Homes at Meadows
Woods

**CITY OF PORTLAND, MAINE
DEVELOPMENT REVIEW APPLICATION
PLANNING DEPARTMENT PROCESSING FORM
Planning Copy**

Stuart Street Subdivision
Project Name/Description

At the Planning Board workshop meeting on July 25, 2000 regarding the Homes at Meadow Woods project, a number of issues were raised by the Planning Board and staff. Following are the issues raised that should be addressed prior to the next workshop meeting scheduled for August 22, 2000.

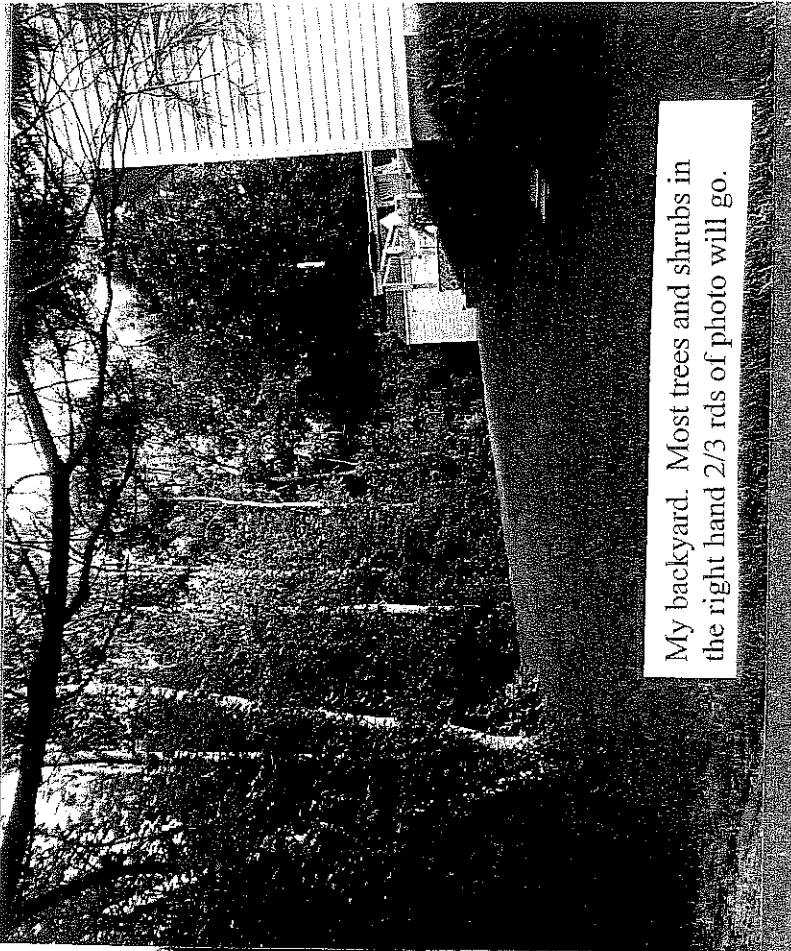
My house - The vacant lot at right will be the entrance to project. Most of the trees behind home and at right will be removed under the current plan.

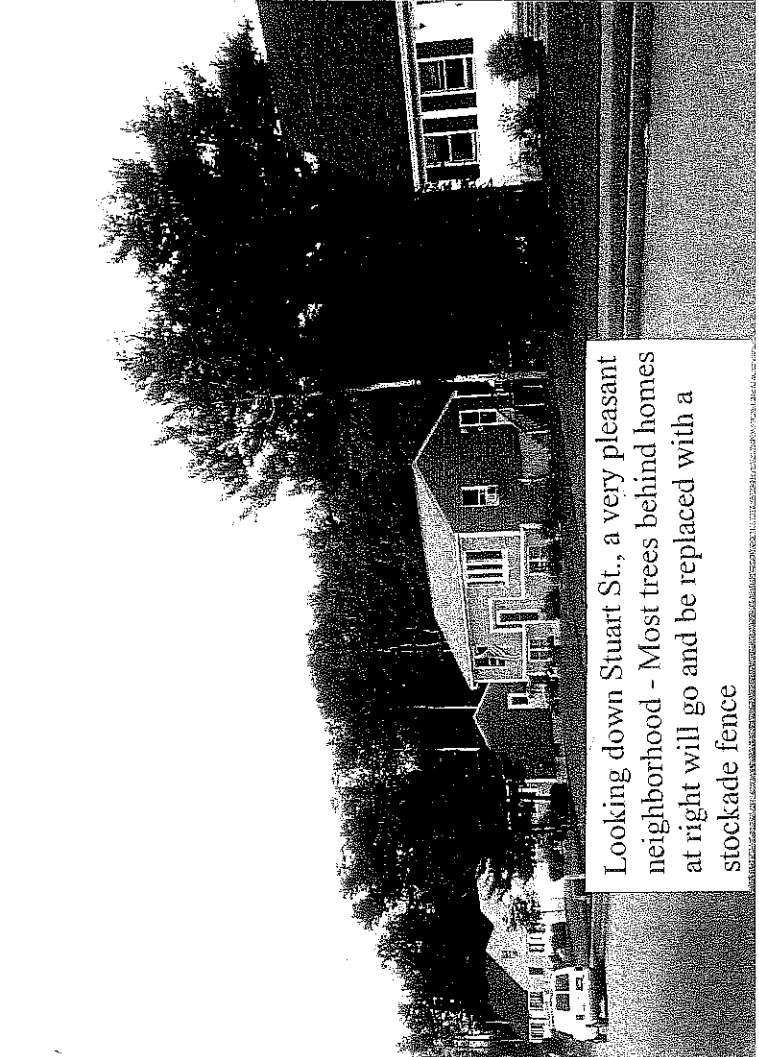
My backyard. Most trees and shrubs in the right hand 2/3 rds of photo will go.

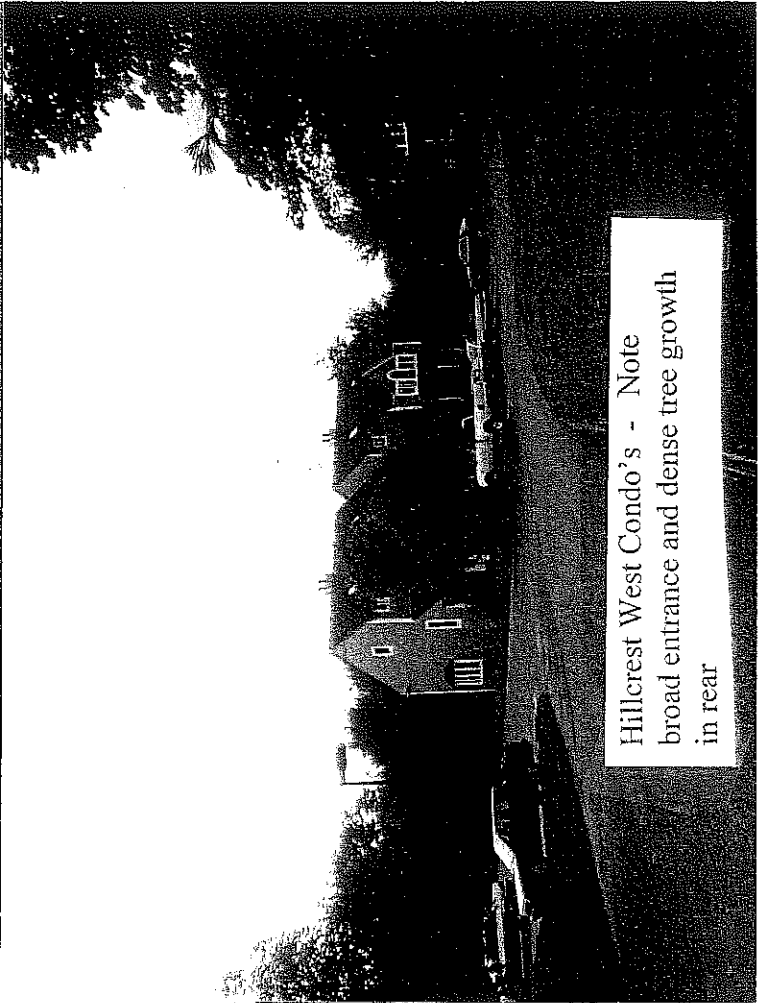
Looking down Stuart St., a very pleasant neighborhood - Most trees behind homes at right will go and be replaced with a stockade fence
